City of Phoenix
PLANNING AND DEVELOPMENT DEPARTMENT

Re: Minor Amendment of Pinnacle Club PUD (Z-57-16-8)

**Re: Minor Amendment to Approved Planned Unit Development Z-57-16-8
("Pinnacle Club") – South of SWC of 44th Street & Thomas Road, Phoenix**

GROUND/STREET LEVEL
2.00

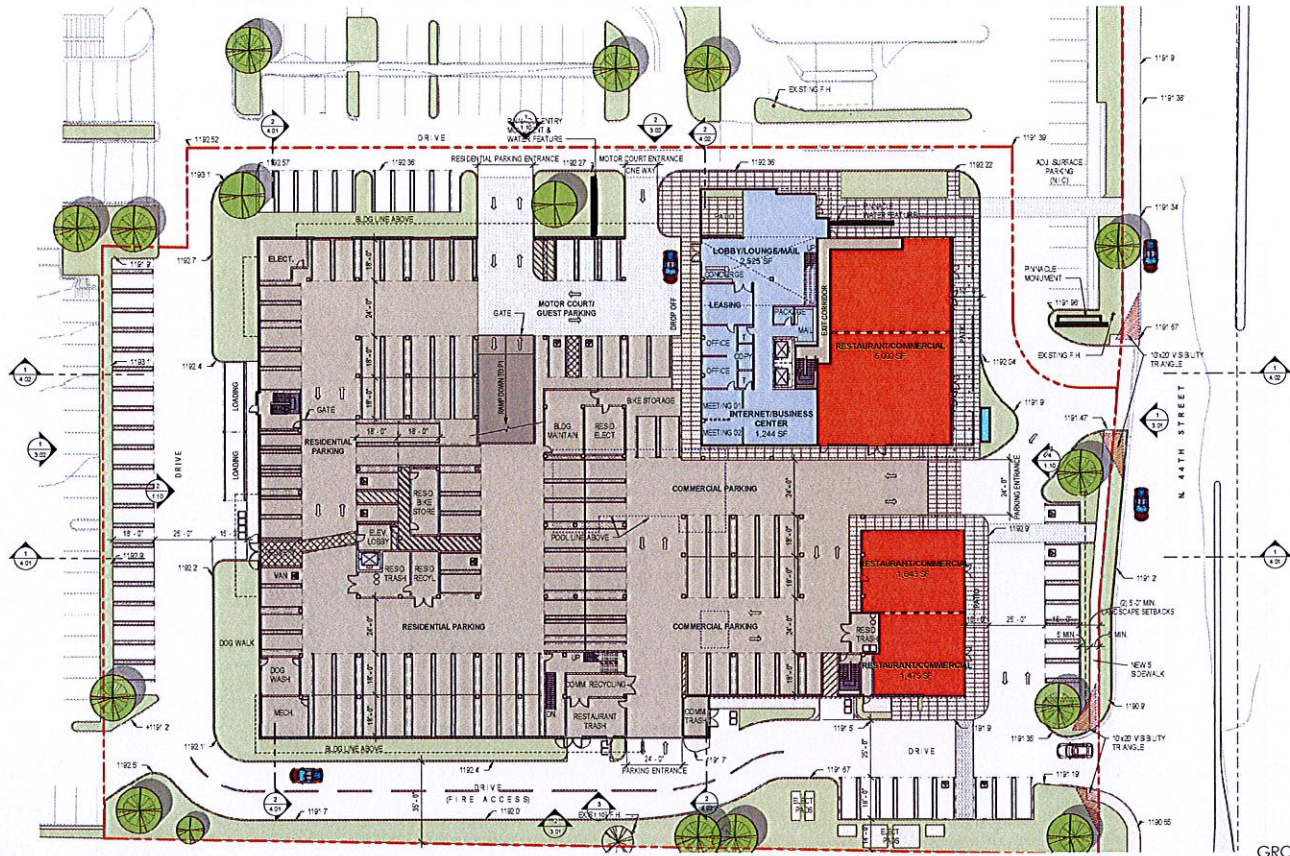
The garage, as currently designed, provides adequate space to accommodate both the residential (including tandem) and commercial parking space widths. However, Ordinance Section 702.B.2.a.(2) requires an additional 18" setback from interior wall or columns for parking garage spaces. This extra 18" is possible for the individual residential spaces (which make up the majority of the garage), but not possible for all of the commercial spaces or all of the tandem spaces.

The discrepancy in residential, tandem residential and commercial parking space widths creates challenges when designing multi-level parking garages for a mix of uses. This is especially true with regard to column alignment and spacing. This garage, for example, has 18" square columns at 30 feet on center. As noted above, this is adequate space to meet the code requirement for residential, tandem residential and commercial parking space widths. However, the extra 18" setback request from the occasional column creates a conflict for some of the tandem residential and commercial spaces.

Considering the majority of the garage is for individual residential spaces, redesigning the garage to accommodate an extra 18" width for tandem residential and commercial spaces which abut columns would create an abundance of wasted, extra space. Moreover, incorporating the extra 18" would reduce the overall number of parking provided in the garage and/or require an additional below grade level to accommodate the needed spaces. Neither of these scenarios is beneficial to the surrounding properties or the property owner.

Parking Space Dimensions	<ul style="list-style-type: none">• Minimum 8.5 feet width• Minimum 18 feet depth
--------------------------	--

<ul style="list-style-type: none">• Dimensions shall apply to single and tandem parking spaces• No setback required from walls or columns
--	--

Parking Space Dimensions	<ul style="list-style-type: none">• Minimum 9.5 feet width• Minimum 18 feet depth• No setback required from wall or columns
--------------------------	---

SUBTERRANEAN PARKING P1 LEVEL
2.06

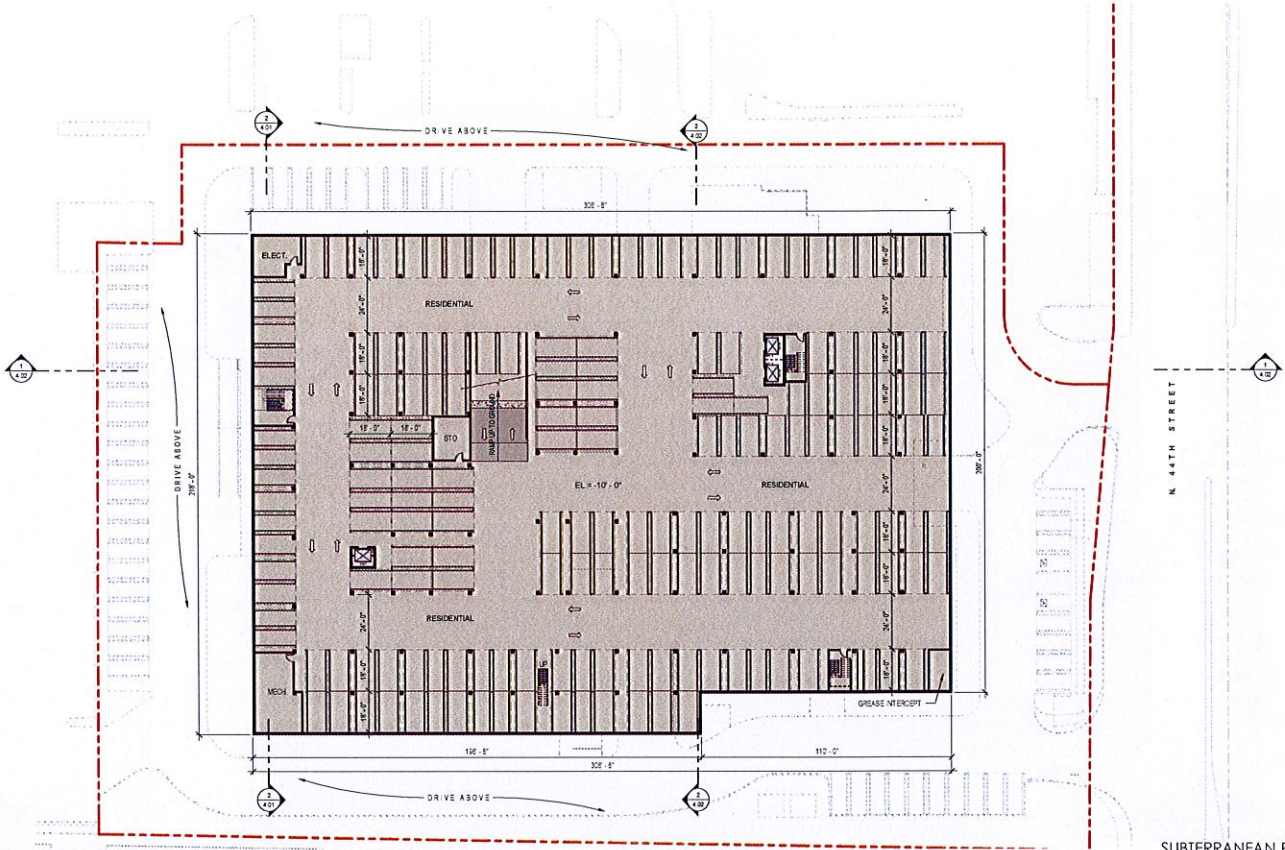
The parking garage consists of an at-grade level and a below grade level. The below grade level is strictly for residents, while the at-grade level is separated into residential and commercial parking spaces. The City of Phoenix Parking Ordinance Section 702.B requires parking spaces to have a width of 8.5 feet for residential use and 9.5 feet for commercial use. However, when two residential spaces are placed together for tandem parking, the code requests 9.5 feet of width.
